UNITED STATES PATENT AND TRADEMARK OFFICE

APPLICATION NO.	FILING DATE	FIRST NAMED INVENTOR	ATTORNEY DOCKET NO.	CONFIRMATION NO.
09/925,562	08/09/2001	G. David Jang	S63.2-9950	6986

Office Action Summary

FIG.2A

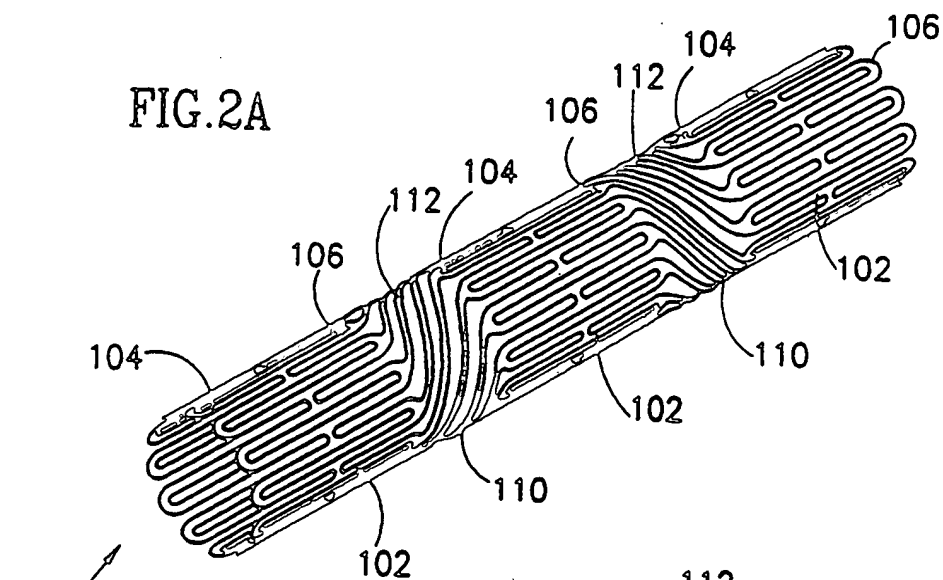
Claims 34, 36, 39, 40, and 42-50 are rejected under 35 U.S.C. 102(e) as being anticipated by Pinchasik et al (US 5,449,373). Pinchasik anticipates the claim language where the first, second and third expansion columns as claimed are the first, second, and third segments (102) of Pinchasik; see Figures 2A to 2C. Applicant is directed to that attached marked-up Figure 2C which shows the expansion struts of segments (102) in red. The other struts (in green) are not precluded by the present claim language.

Alternatively, one could view Brown as not anticipating the claim language because one could say that elements (19a, 19b) are not part of the connecting elements. However, Pinchasik teaches that it was known to make curved interconnectors between adjacent segments; see Figures 2A to 2C and 3A to 3C. Therefore, the Examiner posits that it would have been obvious to make the interconnectors of Brown curved for the same reasons that Pinchasik does the same and in order to better support the area between the segments.
